**RE: Septic System Residence Repair and Local Upgrade Approval
Shepp Residence, 176 Flat Hills Road, Amherst, MA**

To: Board of Health
From: David Zarozinski, Sanitarian
Date: May 16, 2001
Re: Local upgrade approval for Ms Garth Shepp
at 176 Flat Hills Road, Amherst

**Application for Local Upgrade Approval
Title 5, 310 CMR 15.000
DEP Approved form required by 310 CMR 15.403(1)**

SEPTIC SYSTEM REPAIR PLAN FOR GARTH SHEPP		
176 FLAT HILLS ROAD AMHERST, MA		
SCALE: NOTED	APPROVED BY:	DRAWN BY aw
DATE: 10/10/00		REVISIONS <i>10/10/00</i> <i>05107101</i>
COLD SPRING ENVIRONMENTAL, INC.		DRAWING NUMBER 100-1231-0928

CROSS SECTION OF SEPTIC SYSTEM

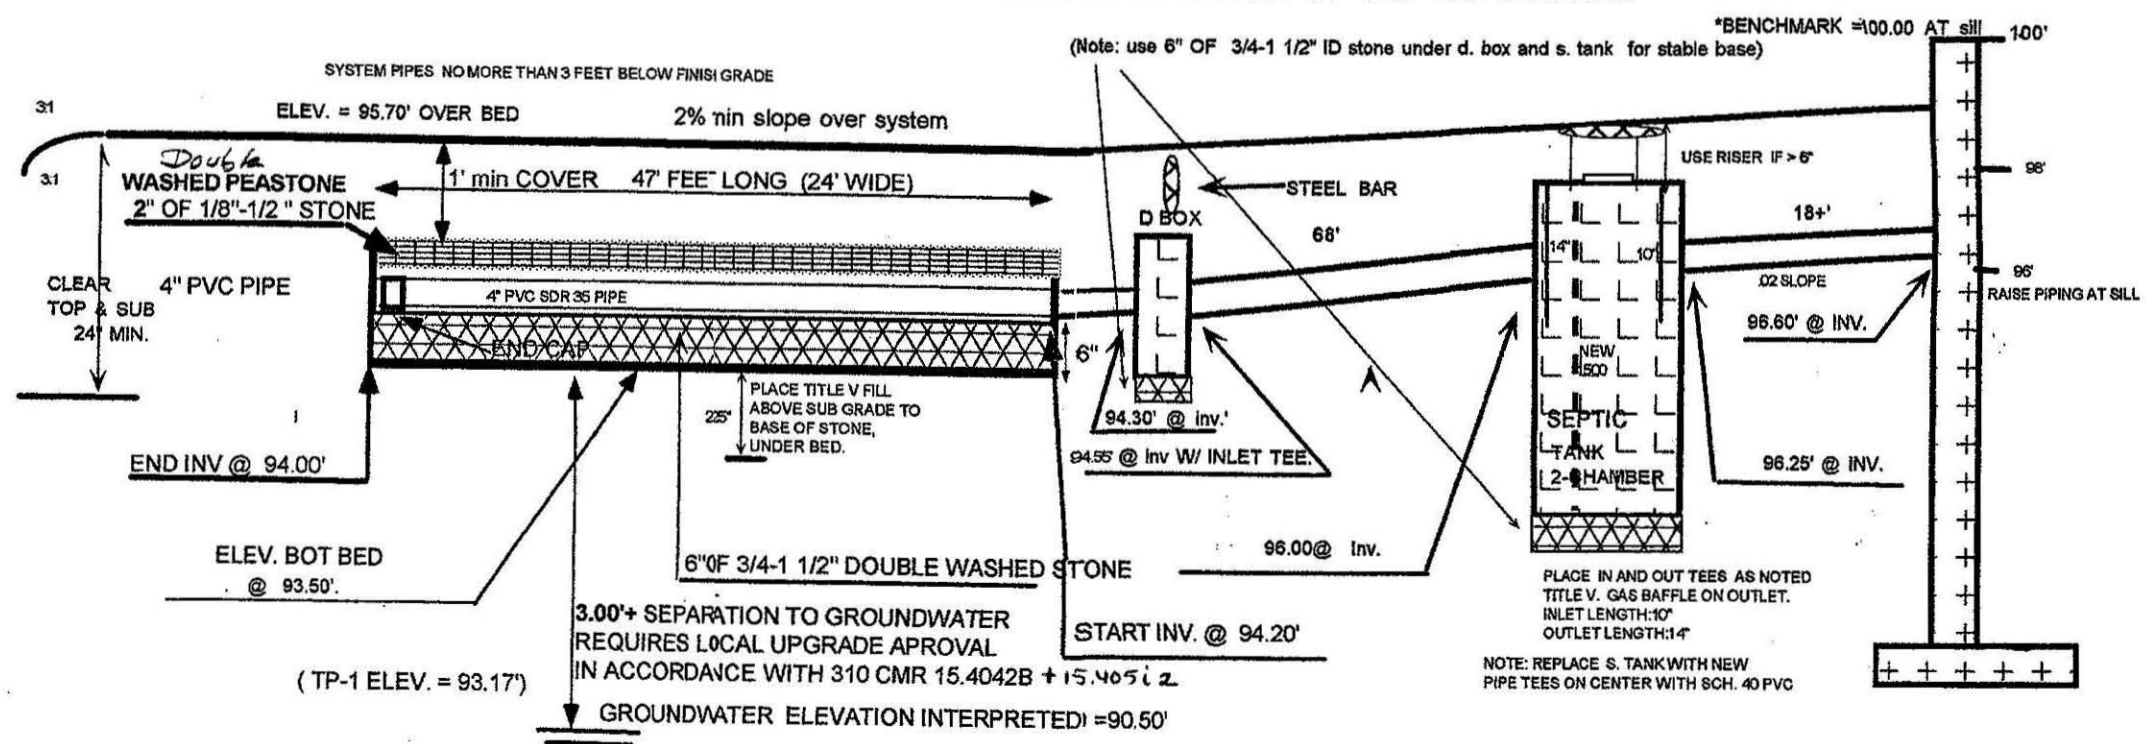
Ms Shepp's request is to allow from Title Five provisions 310 CMR 158.405 (I)(2) a vertical leach separation distance from the required four feet (4') to three feet (3'),

As stated in Mr. Weiss's letter dated May 7., 2001 this approval would minimize the fill placement in order to not create problematic surface runoff patterns associated with excessively raising the ground next to the house.

The designs for this septic system have met all other D.E.P. regulations and therefore, I would grant the local upgrade. This design of the system will allow for both the best feasible upgrade within the borders of the lot, and have the least effect on public health, safety and the environment.
